Inspection Report

Project	LBST Jetty Pile and Headstock Remediation
Date	10th July 2026
Inspected by	David Edelman
Areas inspected	Pilebent 257 completed, scaffold still in place Pilebent 260 final inspection Pilebent 262 final inspection Pilebent 263 final inspection Pilebent 270 scaffold under construction Pilebent 271 progress inspection Pilebent 273 progress inspection Pilebent 281 progress inspection
Weather conditions	Rain until around 10am then fine. Moderate wind and swell

1. DFT gauge check

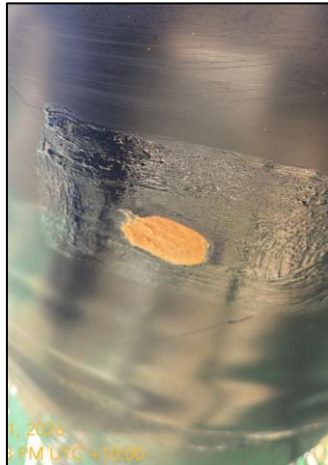
- Accuracy confirmed on 518µm shim on flat steel plate blasted by AAB during the works.
- Rod's DFT gauge and my DFT gauge seem to read differently by around 50 to 100µm with mine reading lower. We need to check them together on a shim or certified thickness standard.
- Both gauges are recently calibrated and are within acceptable error margins. Rod's gauge is 0-5000µm and mine is 0-2000µm range.
- As Contractor is generally easily meeting DFT specification, there is unlikely to be a dispute arising from gauge differences.

3. PB263 – Final inspection

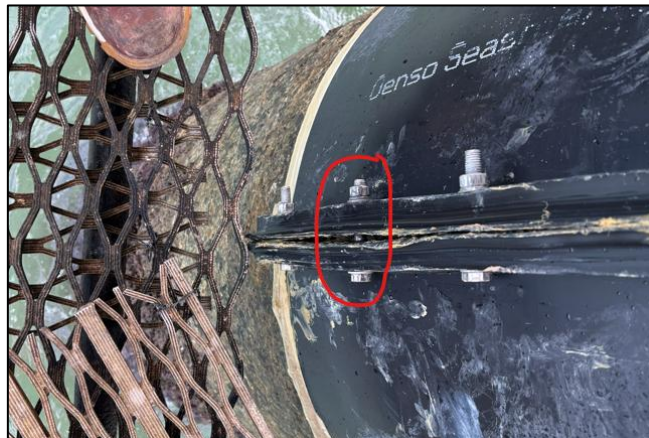
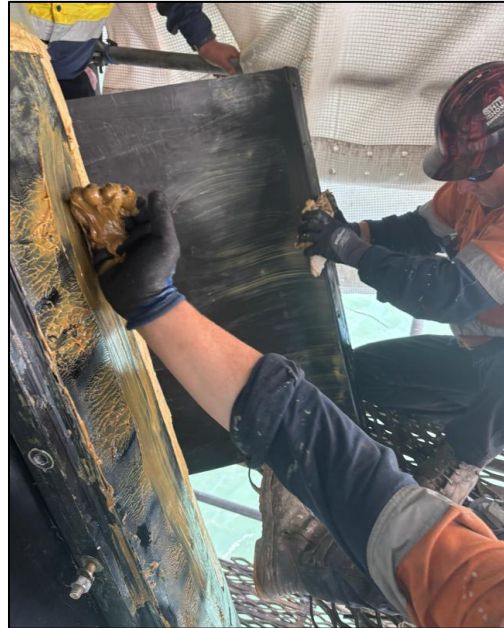
- Small stones under jacket were removed after being noticed by Contractor QA process
- 2 galled bolts removed and replaced on lower deck

4. PB263 – Final inspection

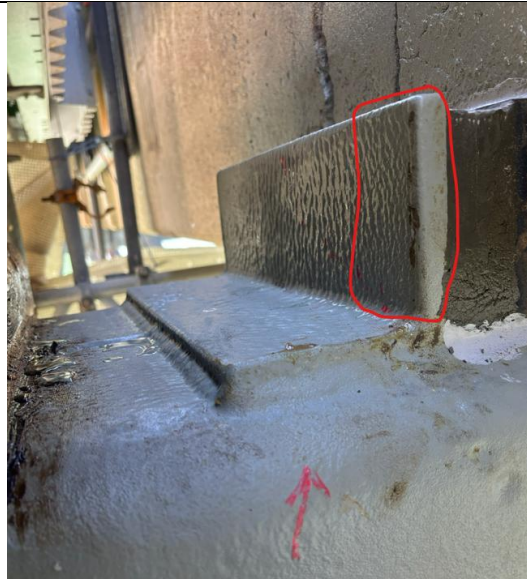
- One isolated low DFT area marked up for repair

5. PB271 – Awaiting welding

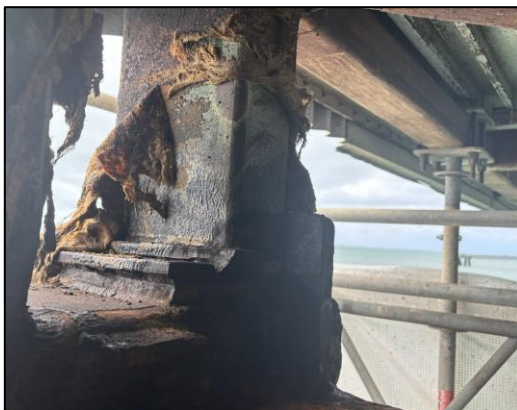
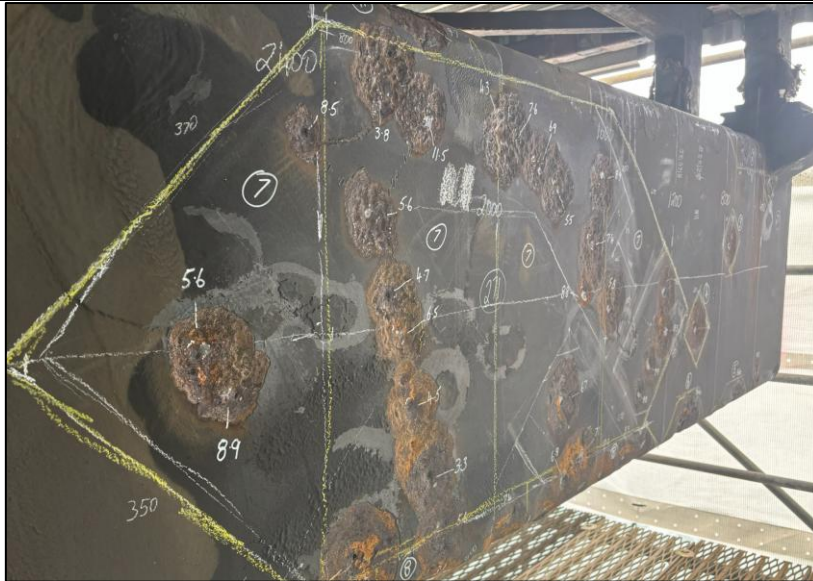
- Large areas of weld repair required
- Deep small pitted/porous areas that can't be painted on underside
- Feet look good (though not fully cleaned)
